INCORPORATED COUNTY OF LOS ALAMOS

**Invitation for Bids No. IFB24-22
IFB Name: Airport Fuel Farm Project**

Addendum No. 4

**GRAVITY SEWER MAIN
 TRENCH DETAIL**

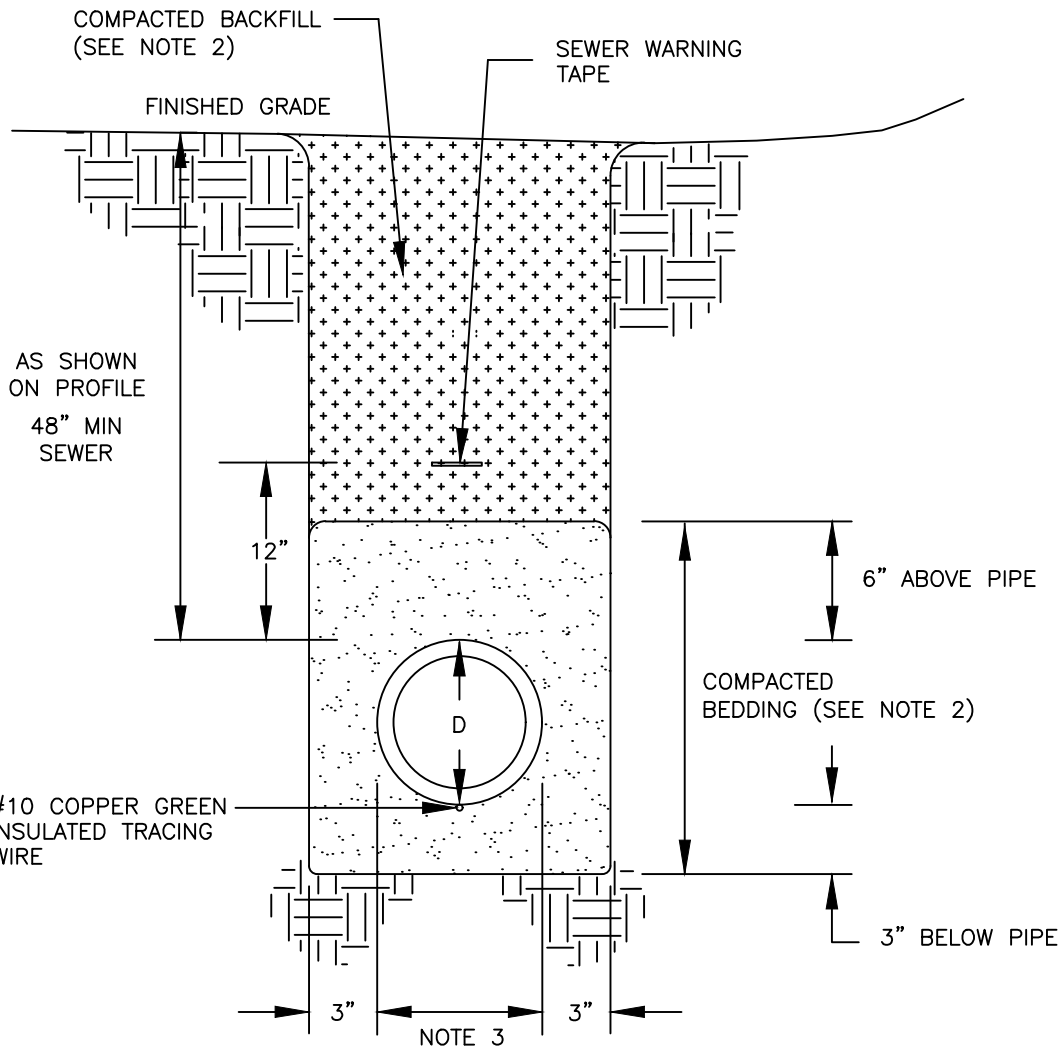
4. Is there a sewer manhole detail or section drawing available, didn't see one in the site plans.

Response: See attached County Department of Public Utilities Construction Standard Drawings 5005 and 5008-A. Standard Drawing 5003, also attached, provides additional related information for sanitary sewer construction. Refer to Plan Sheet C-3, General Note for additional reference information.

PRECAST ECCENTRIC MANHOLE

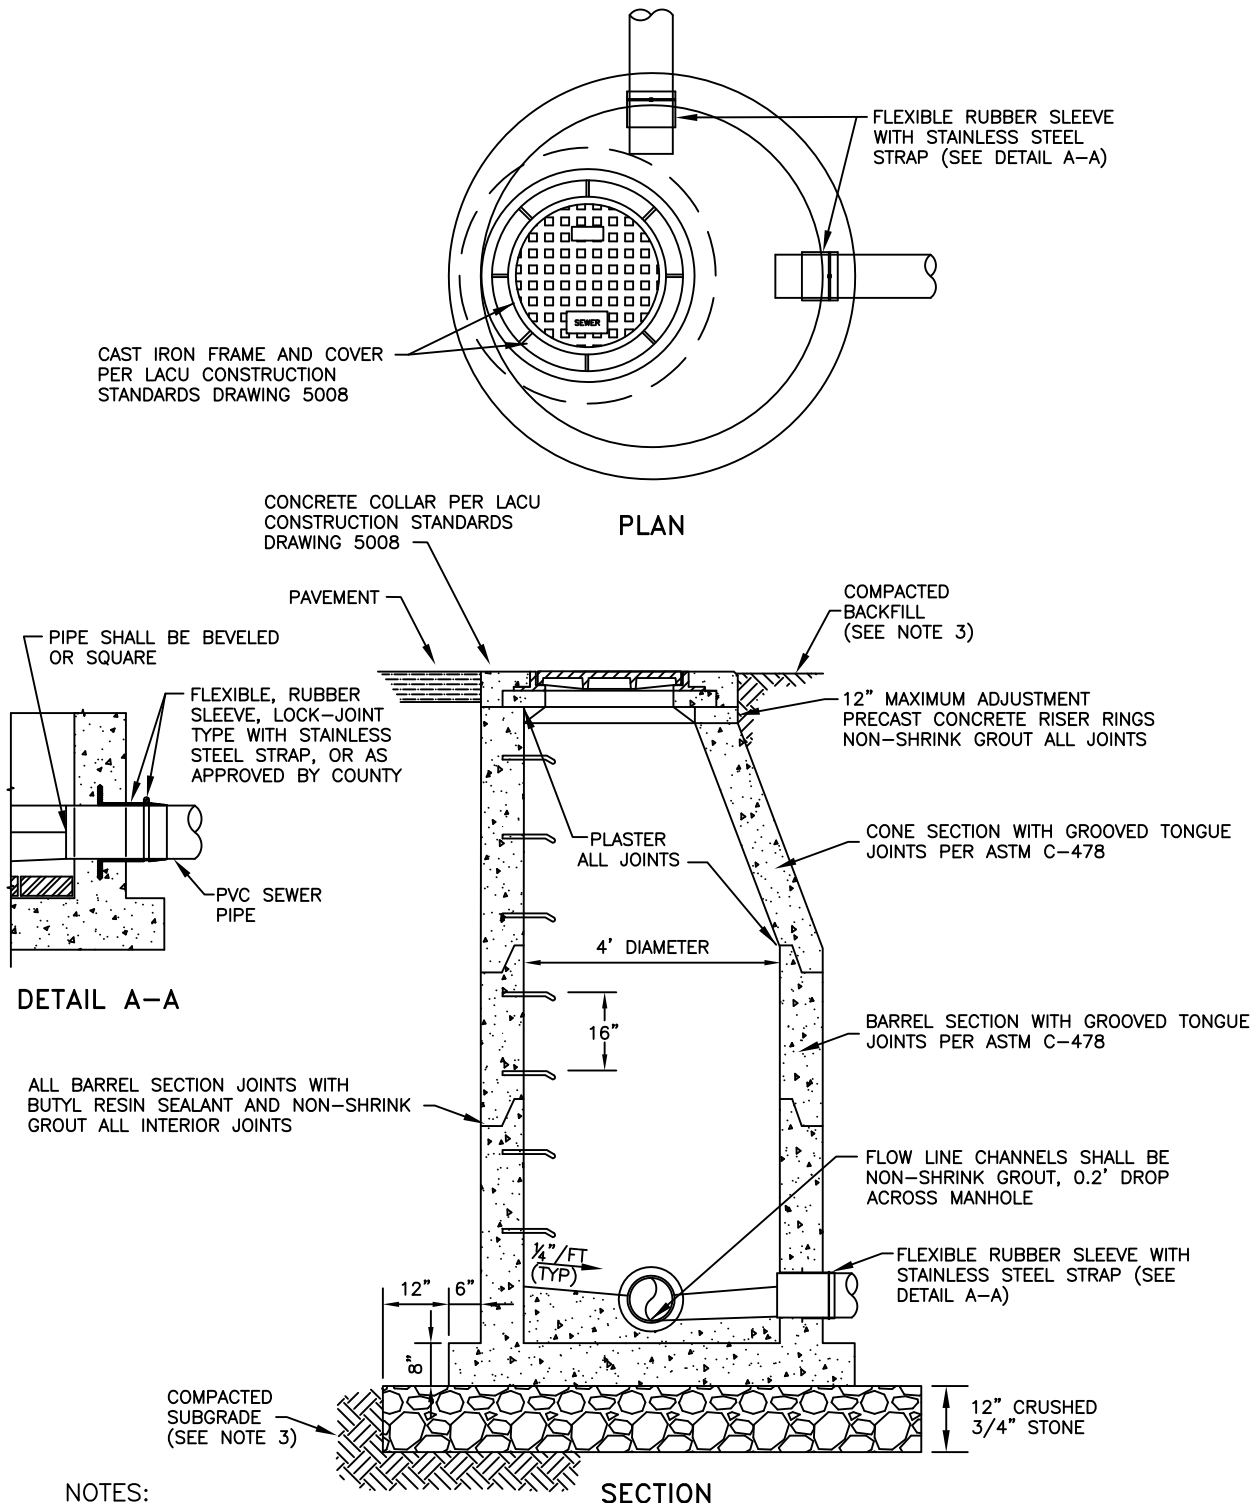
5. Is there a sewer manhole build type preferred, i.e., Type-C, Type-E?

Response: See response to number 4 above.
